TECHNICAL NOTE - D.7.47

DATE:	04 July 2023	CONFIDENTIALITY:	Public
SUBJECT:	Change Request 3 – Environment Technical Note		
PROJECT:	HyNet - DCO	AUTHOR:	Various
CHECKED:	MT	APPROVED:	CL

An Environmental Statement (ES) was submitted to the Planning Inspectorate (‘the Inspectorate’) in October 2022 as part of a Development Consent Order (DCO) application (EN070007) for the HyNet Carbon Dioxide Pipeline development (hereafter referred to as the ‘DCO Proposed Development’). A Consolidated ES was subsequently issued at Deadline 4, this incorporated proposed changes that had been accepted by the ExA as part of Change Request 1 [CR1-124] and Change Request 2 [CR2-017]. The consolidated ES (hereafter referred to as the ‘ES’) sets out the findings of the full Environmental Impact Assessment (EIA) that was carried out for the DCO Proposed Development.

Figure A1 – Before and after the removal of Shotton Lane Centralised Compound and reduction to Newbuild Infrastructure Boundary – Works Plan

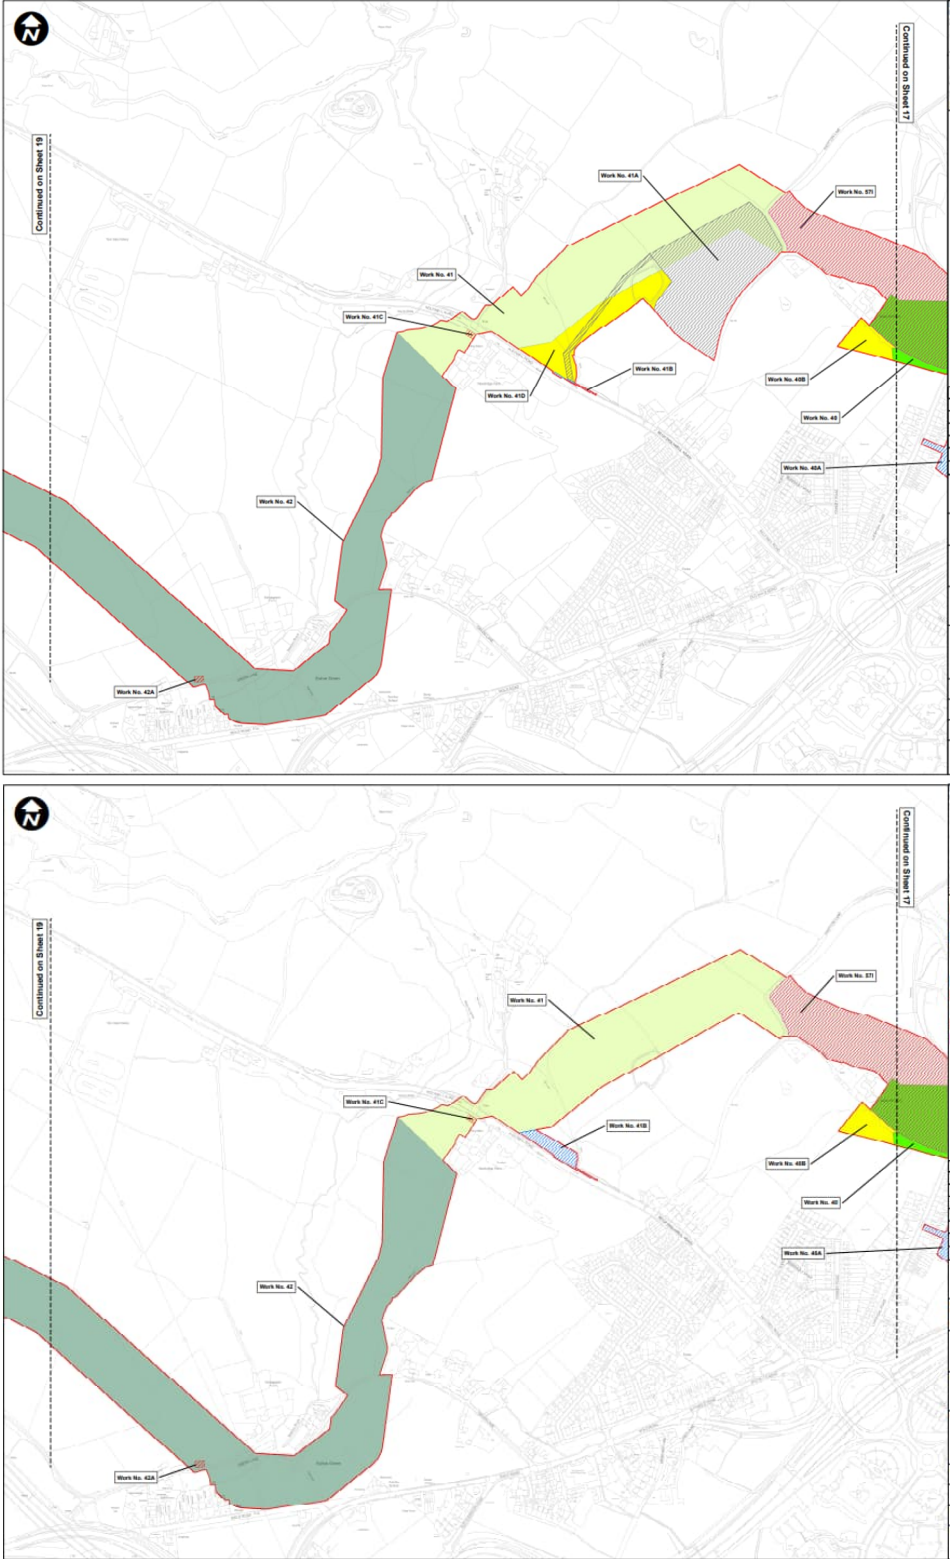
The Applicant is proposing a change to the proposed DCO Proposed Development as a result of continuing engagement with the landowner. This change would see the removal of the Shotton Lane Centralised Compound (Work No. 41A in **Figure A1** in **Annex A**).

Figure A2 – Before and after the removal of Shotton Lane Centralised Compound and reduction to Newbuild Infrastructure Boundary – Land Plan

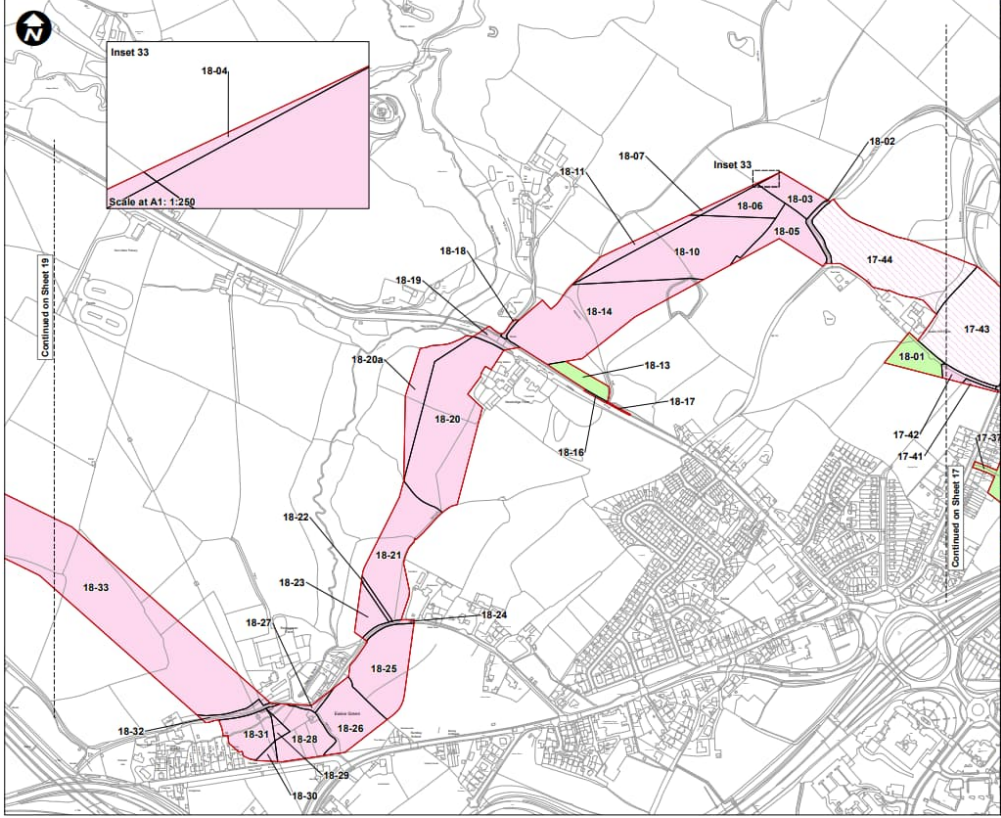
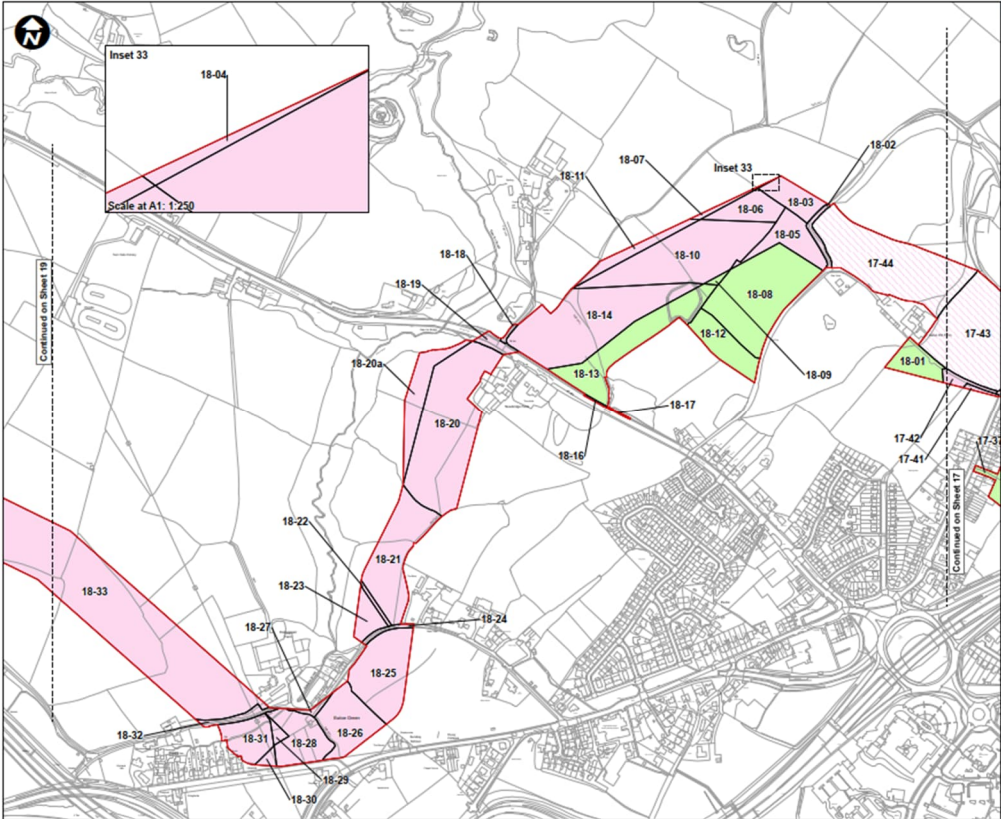
The removal of the Temporary Logistics and Construction Compound (Work No.41A), and removal of the Temporary Working Area (Work No. 41D) requires the extension of the

Temporary Access (Work No. 41B) to meet the Carbon Dioxide Pipeline Works (Work No. 41), to ensure access is maintained. This will result in the removal of land from the Order Limits (specifically land parcels 18-08, 18-09, 18-12 and the partial removal of parcel 18-13), and no new land will be impacted (**Figure A2 in Annex A**).

Figure A3 – Before and after the reduction to the Newbuild Infrastructure Boundary at Ince AGI

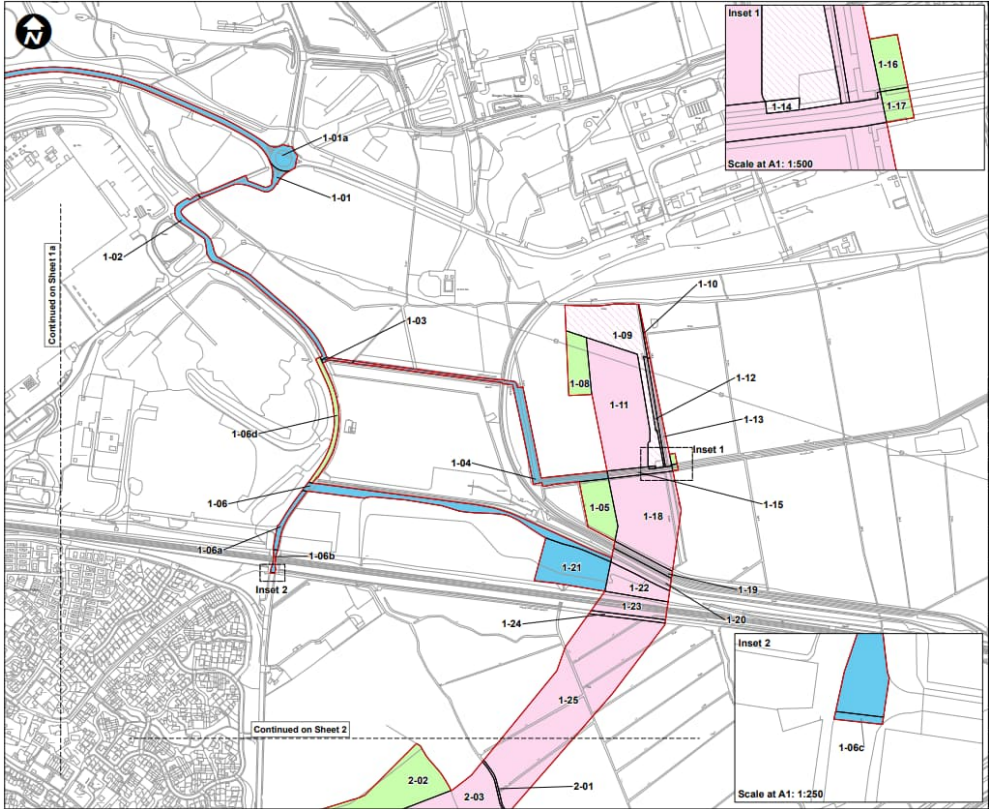
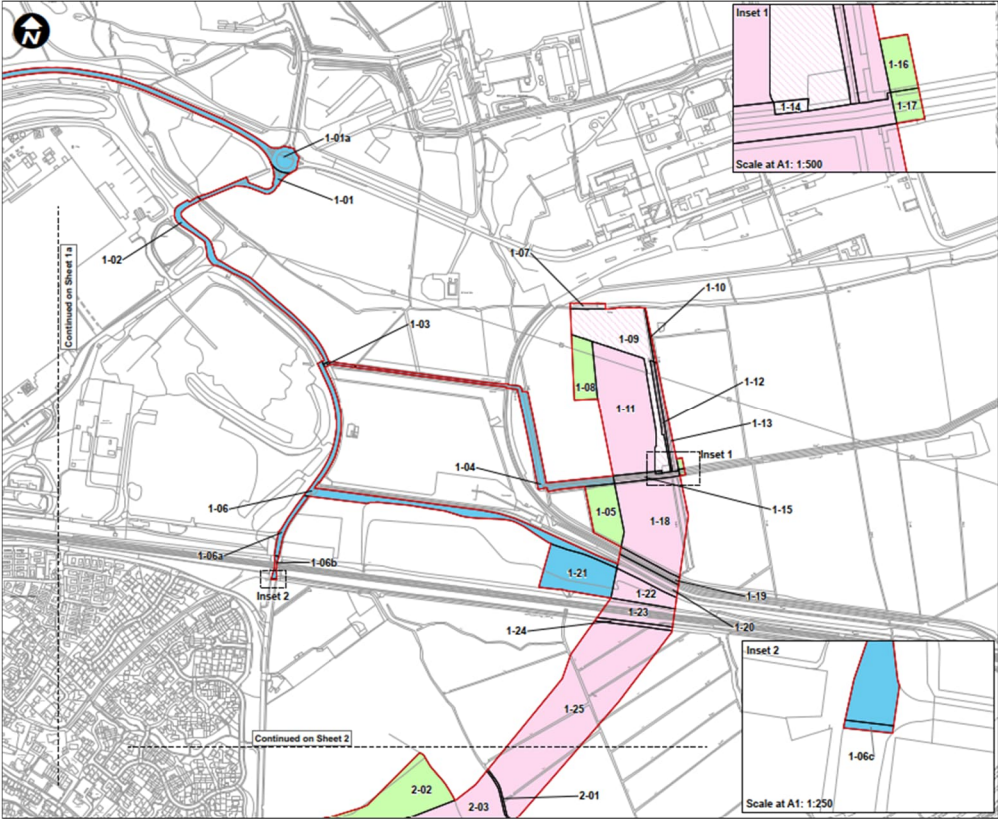
The Applicant proposes the removal of Plot 1-07 (**Figure A3 in Annex A**) and updates to the Outline Surface Water Drainage Strategy (**Figure A4 in Annex A**), due to the request from the interested landowners to avoid the outfall for the Ince AGI drainage pond connecting into the East Central Drain.

Figure A4 – Before and after the change to Outline Surface Water Drainage Design

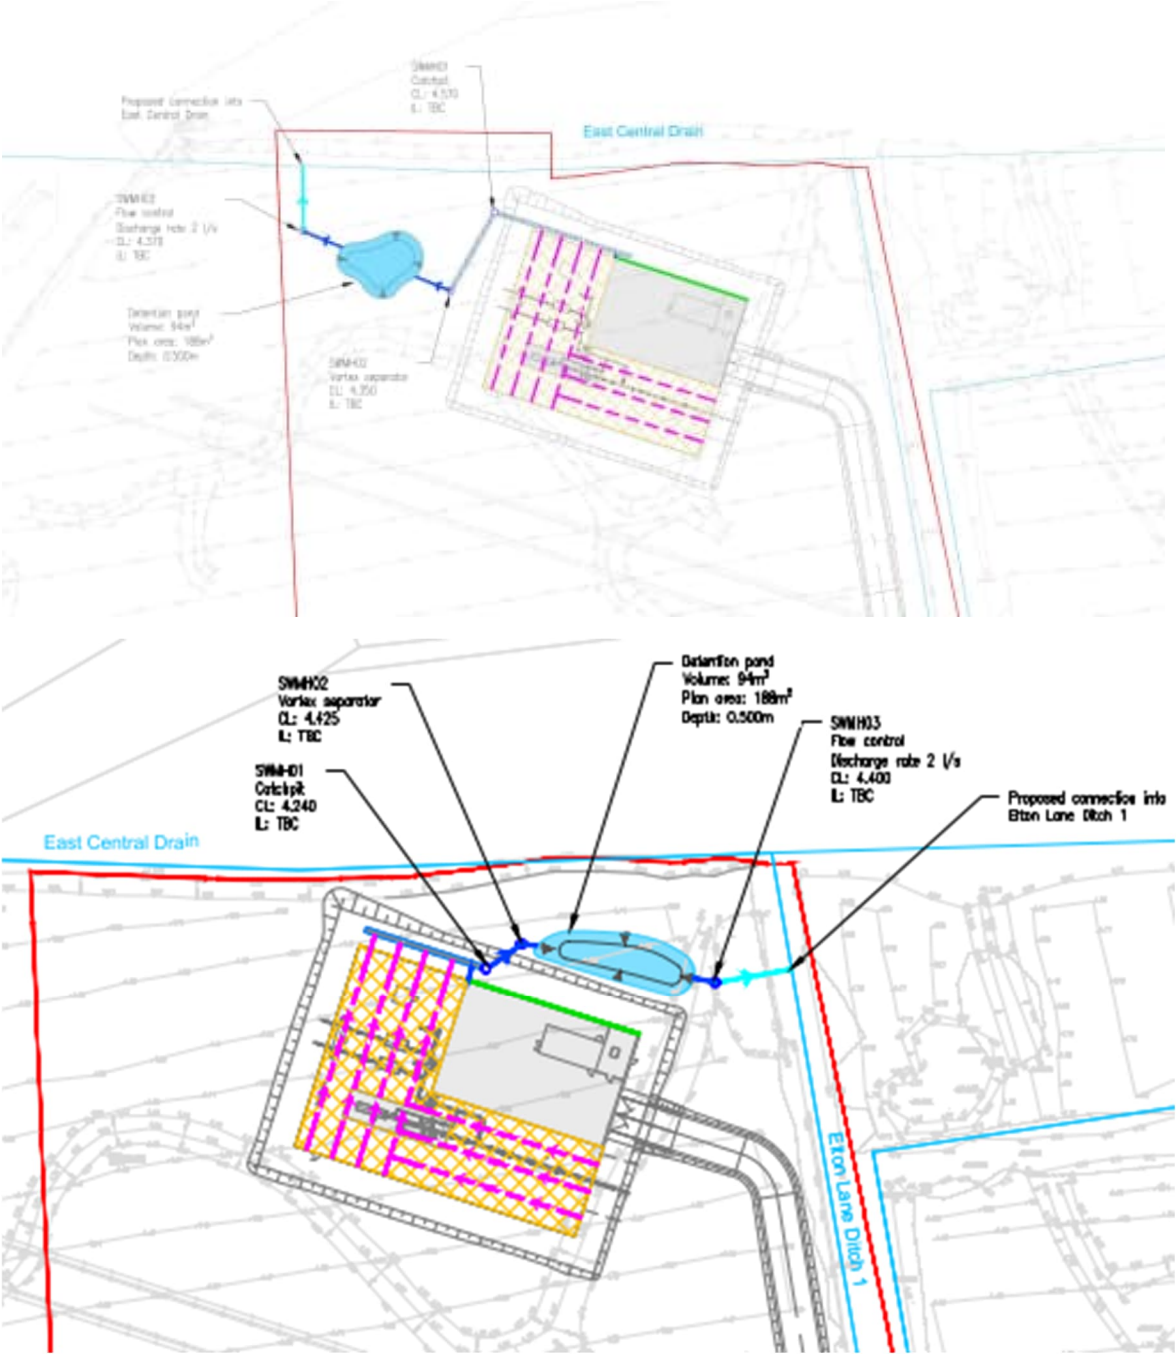
Paragraph 3.4.12 of Chapter 3 [REP4-029] will be changed to state *'The OSWDS (Document Ref: D.6.5.13) assumes for Ince AGI that discharge would be to Elton Lane Ditch 1 via an infiltration trench on the gravelled areas, vegetated attenuation pond and filter channel.'*

Figure A5 – Before and after the reduced Newbuild Infrastructure Boundary at Picton Lane – Land Plan

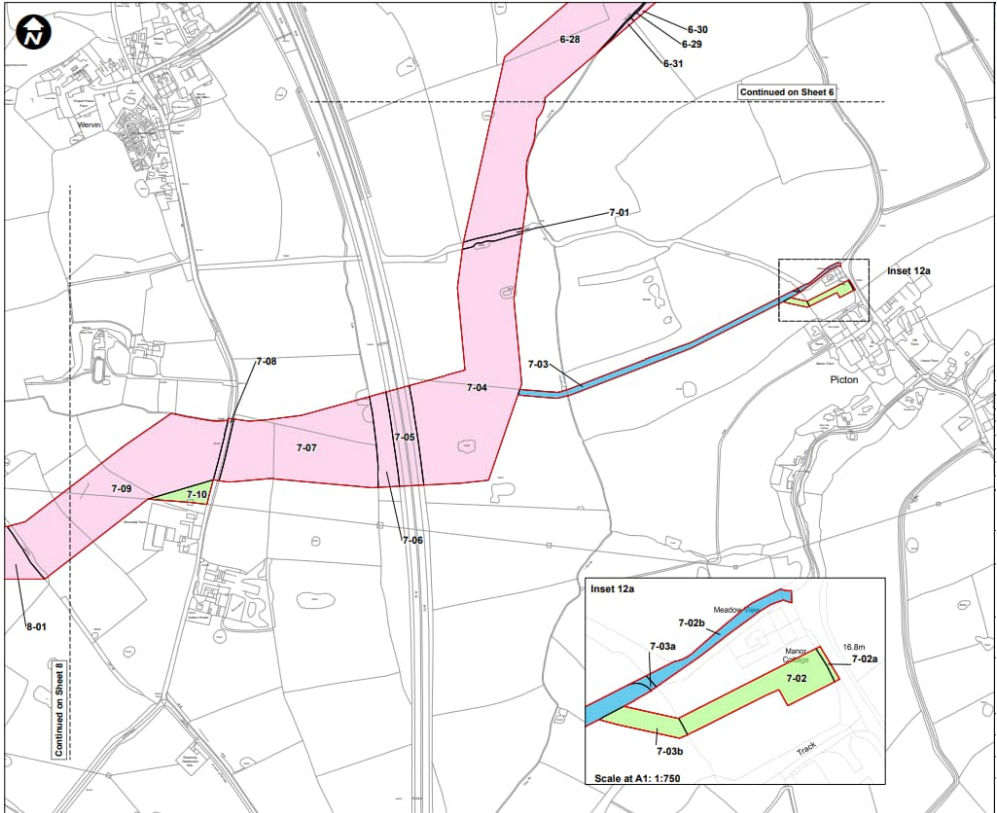
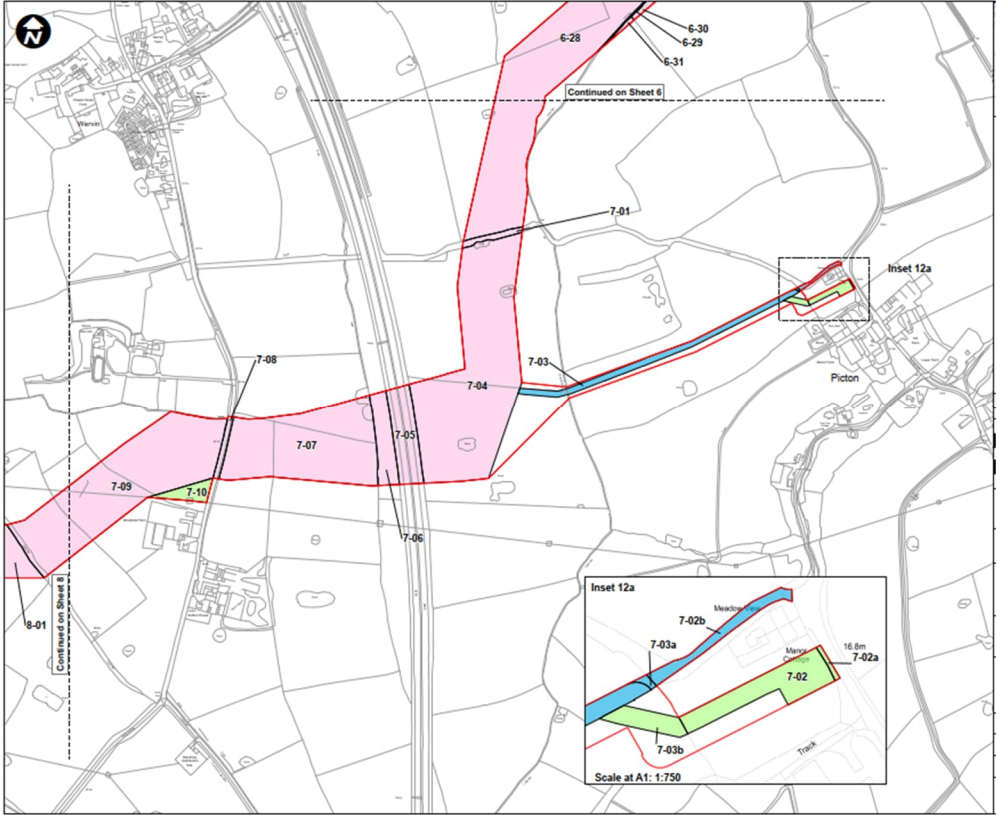
The Applicant proposes removal of land from the Order Limits at Picton Lane to minimise land take required for construction and operational access at Work No. 16A and Work No. 16B, and to bring the Order Limits in line with the land plot changes, submitted at Deadline 4, made at the landowner's request.

The Applicant has reviewed the land associated with the haul route at Picton Lane (plot 7-02 and plot 7-03) and concluded that the allocated land can be reduced.
